BLAKENHAM FIELDS, GREAT BLAKENHAM

Review of Transport Assessment, Addendum Transport Assessment and
Proposed Off Site Highway Works

09/12/2014

Figure 1 Conflict between refuse vehicle and building

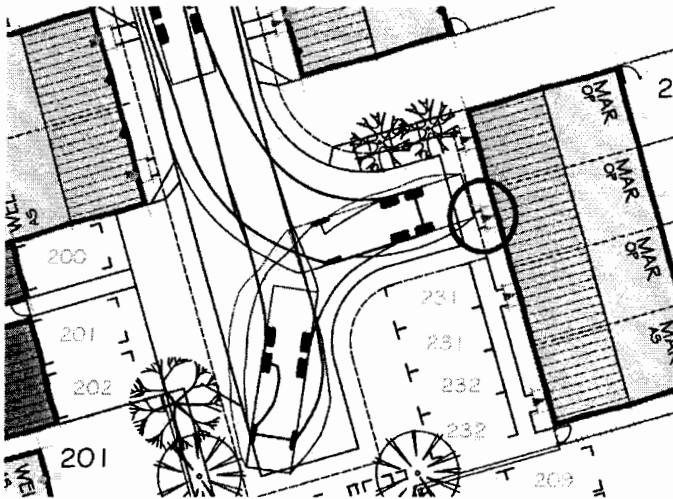
2.7.2 Appendix J contains swept paths of a refuse vehicle. The swept path in the bottom right hand corner of the drawing appears to show the refuse vehicle reversing to within about 200mm of the porch of unit 230 (there was no scale on the drawing, but it appears to be at 1:200). There is significant risk that the refuse vehicle could collide with this porch, and a risk that a pedestrian could emerge from the building while the vehicle is reversing. This arrangement is therefore not acceptable.

Figure 2 Refuse vehicle crossing outside adoptable highway

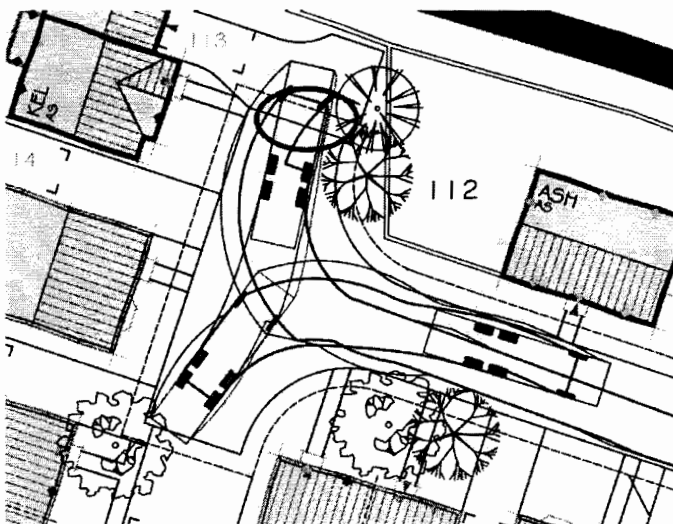
2.7.3 The swept path in the bottom right hand corner shows the wheels of the refuse vehicle passing outside the solid lines of the turning head by unit 113 (assumed to be the extent of adoptable highway). The applicant should confirm that the refuse vehicle is able to turn around within adoptable highway.

Figure 3 Area where forward SSD appears to be obstructed by proposed planting

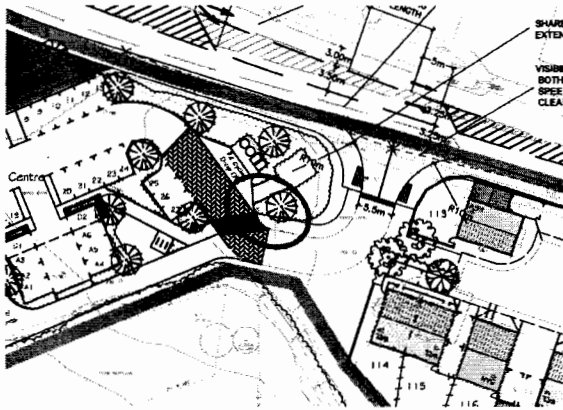
- 3.1.1 The TA should provide swept path drawings to demonstrate that the largest servicing vehicle that is expected to serve the proposed convenience store can enter and exit the access junction, travel along the access road and turn around within the proposed servicing area of the convenience store, as the right angle bends within the site appear to be very tight for a large vehicle.
- 3.1.2 Within the village centre area, the vegetation between Gipping Road and the proposed access road could obstruct the forward stopping sight distance (SSD) around the bend, particularly from the proposed recycling drop-off (see Figure 3). A drawing should be provided to show the stopping sight distance on the convenience store access road is not obstructed.

Figure 4 Pedestrian desire lines at Hackneys Corner Junction

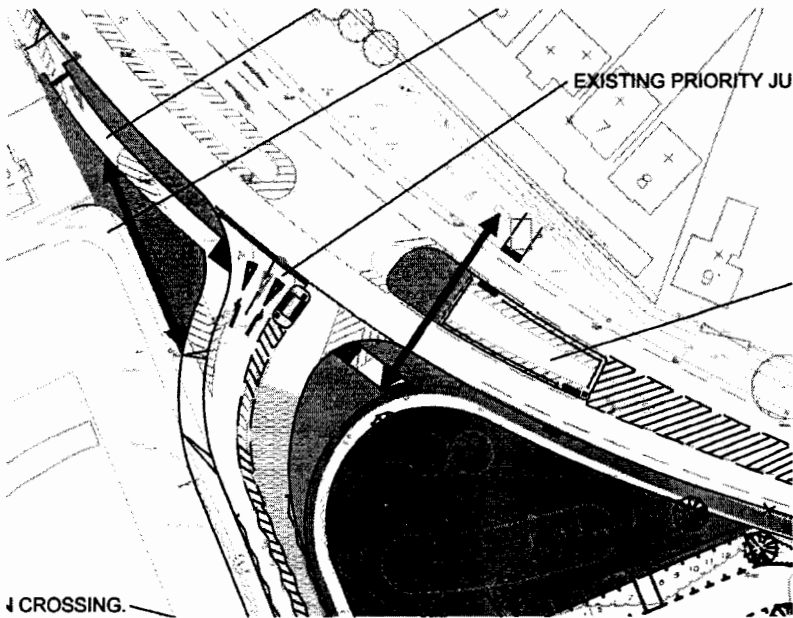
- 3.2.1 The proposed changes to the Hackney's corner junction appear to be reasonable. There is however a pedestrian desire lines which are not catered for by the proposed footways in the scheme which are likely to result in pedestrians walking across the verge. There is also potential for pedestrians to cross Gipping Road using the verge to the west of the refuge island.

Figure 5 SSD to Primary Signal Head

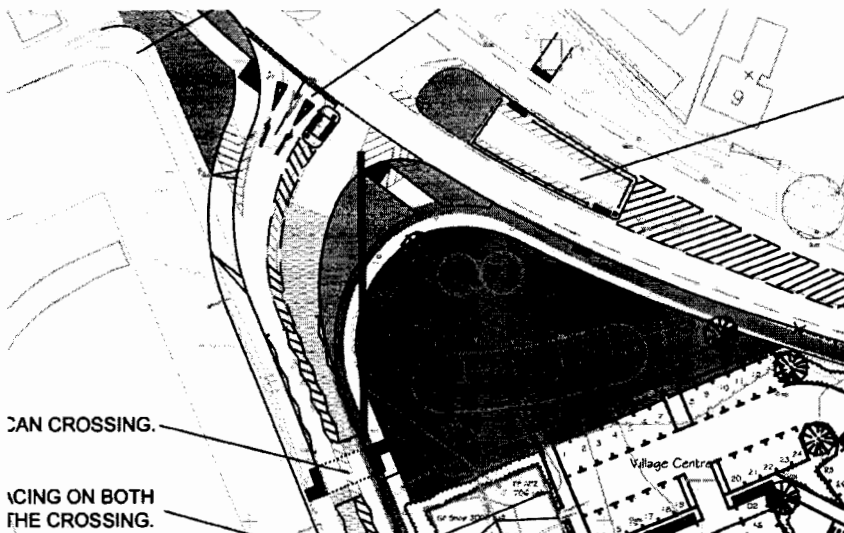
3.2.3 Although the locations of the signal heads at the proposed toucan crossing are not shown on the drawing, it appears that the stopping sight distance to the southbound primary signal head would cross the village green area, potentially outside of land that is likely to be designated as public highway (see Figure 5). A drawing should be provided showing the stopping sight distance to the primary signal head, to demonstrate that the visibility splay can be provided within highway land

Figure 6 Pedestrian Desire Line at Bramford Road Access

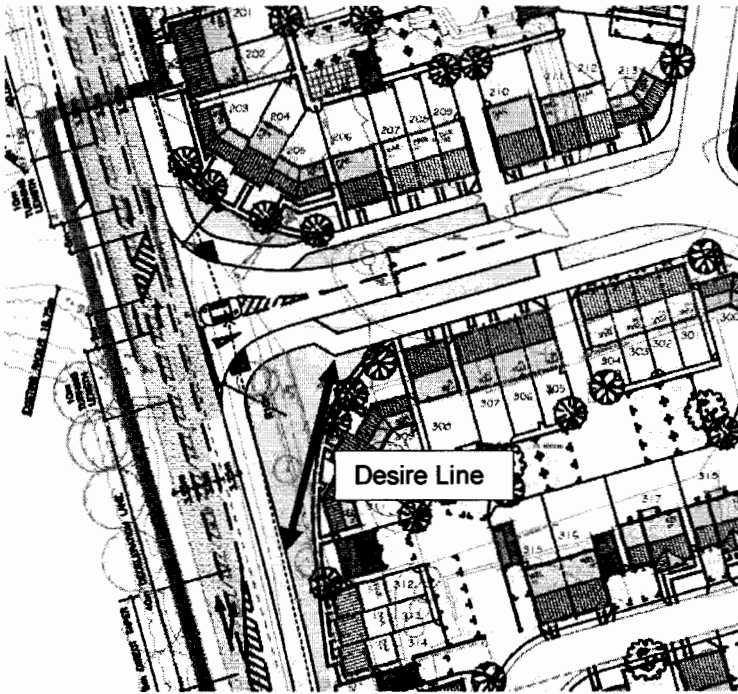
- 3.3.1 The junction arrangement shown on the Bramford Road access drawing appears to be acceptable; however, the TA should provide a drawing showing that the swept paths of the largest vehicle that will use the junction can be accommodated.
- 3.3.2 Consideration should be given to providing a footway on the likely pedestrian desire line shown on Figure 6, as it is unlikely that pedestrians would walk the additional distance around the kerb if they were heading south on Bramford Road

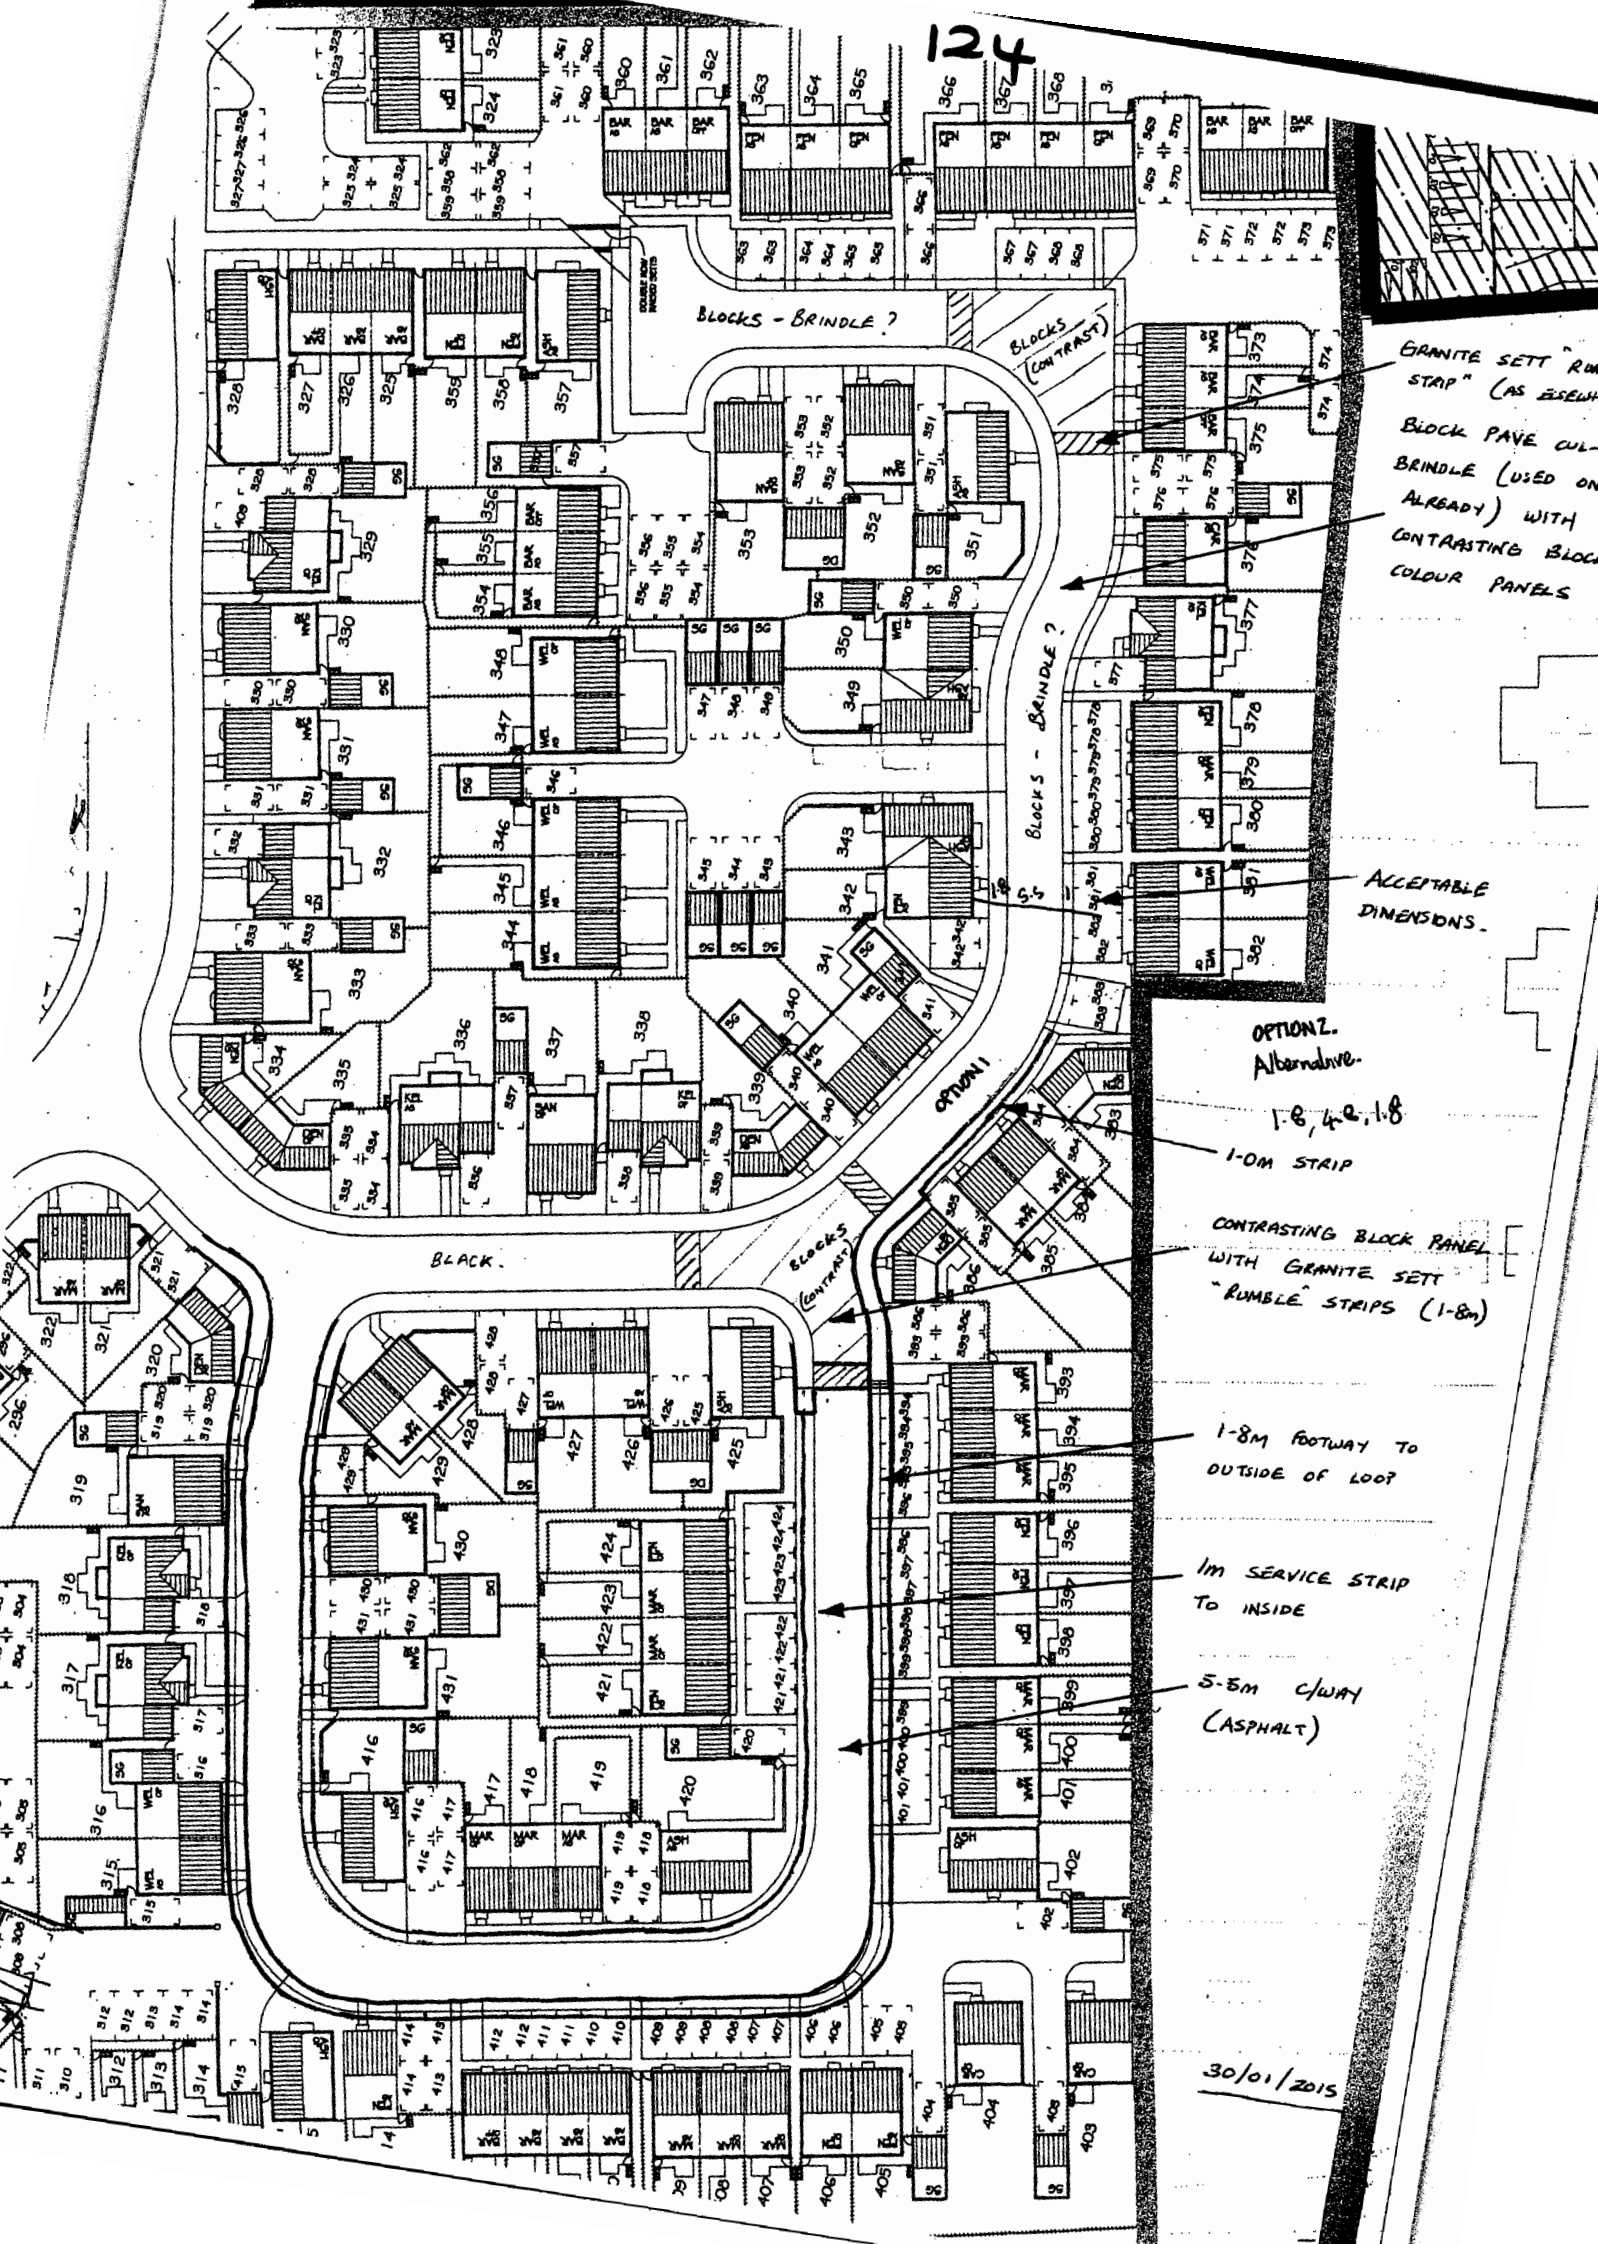
As discussed yesterday please find attached an extract of the layout drawing which you kindly left with us. I have indicated some adjustments and included some notes which I hope are of assistance.

Many thanks for the revised layout, Drawing Number LLC926-AP5-100 Revision P. I confirm that this is acceptable in highway terms.
